**BOARD OF ZONING ADJUSTMENT
STAFF REPORT****Date: August 1, 2011****CASE NUMBER**

5695

Alabama Realty Company, Inc.

LOCATION2600 McVay Drive North
(North side of McVay Drive North, 290'± West of Navco Road)**VARIANCE REQUEST****HEIGHT:** Height Variance to allow the construction of a 130' telecommunications tower in a B-1, Buffer Business District (rezoning pending).**SEPARATION BUFFER:** Separation Buffer Variance to allow the tower within 50' of residentially zoned property with no landscape buffer or buffer fence.**SETBACK:** Setback Variance to allow the tower within 69.8' of the North lease parcel line, 50' of the West lease parcel line, and 103.5' of the South lease parcel line.**SURFACING:** Surfacing Variance to allow aggregate access and parking.**PARKING:** Parking Variance to allow no designated parking.**LANDSCAPING AND TREE PLANTING:**

SITE PLAN

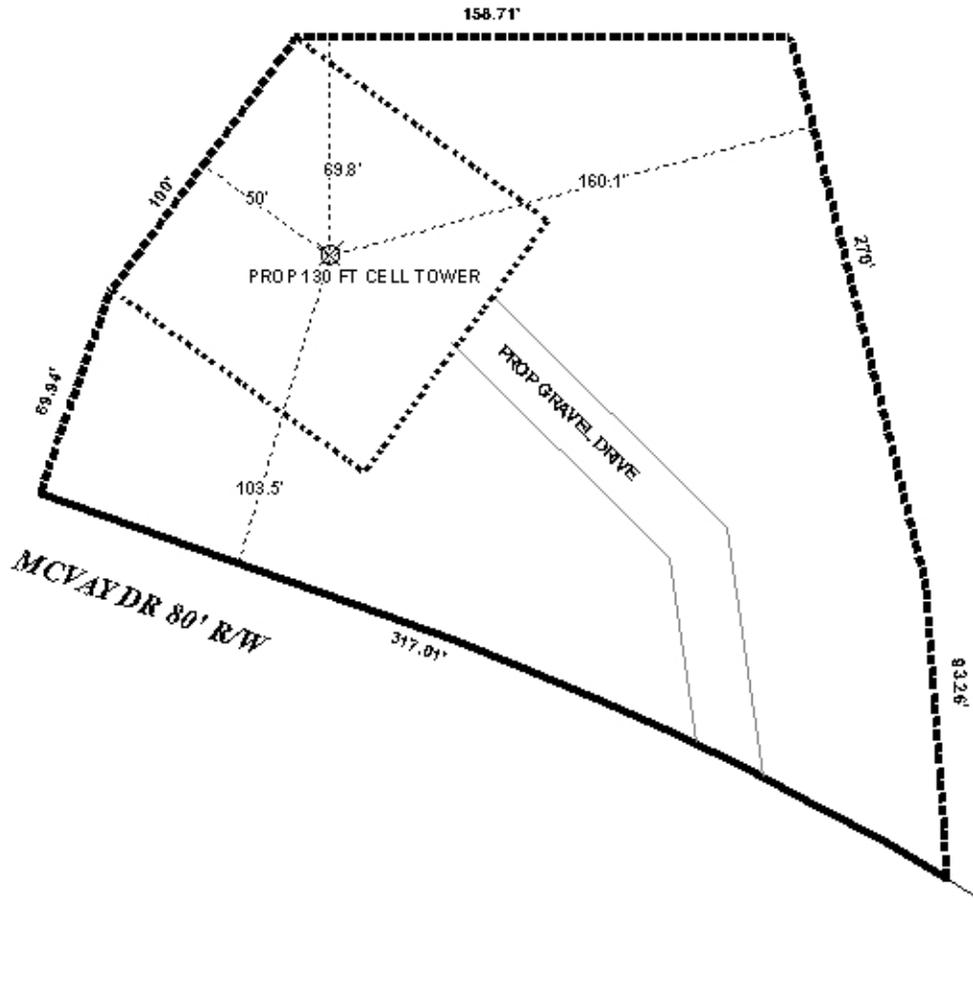
With regard to the Setback Variance request, the tower is proposed to be of monopole design, and as such, is engineered to fall within a 50’ radius of the base in the event of collapse which would warrant the reduced setbacks off the lease parcel lines.

The applicant requests the Surface Variance since the drive would be of low use and utilized only by company personnel. The reasoning behind requiring compliant paving for access and parking is to reduce the possibility of gravel surfacing being carried by tires onto the right-of-way and creating a hazard due to slinging from the tires. No hardship basis is presented by the applicant on this request.

The applicant states that there would typically only be one vehicle per week on the site while checking the tower equipment and the area within the compound could be utilized for parking. Normally, the parking area is located outside the compound to allow maneuvering area for the vehicle to turn around on a paved surface. No basis for a hardship associated with the parking space requirement has been illustrated by the applicant.

RECOMMENDATION: Based on the preceding, the Height, Separation Buffer and Setback Variance requests are recommended for approval subject to the following conditions:

- 1) the tower is limited to a monopole design with a maximum height of 140', including the lightning rod;
- 2) provision of a separation buffer or wooden privacy fence if the adjoining residentially-zoned property to the North and East are ever developed residentially;
- 3) provision of landscaping and tree planting, to be coordinated with Urban Forestry; and
- 4) full compliance with all other municipal codes and ordinances.

The requests for Surfacing, Parking, and Landscaping and Tree Planting Variations are recommended for denial.
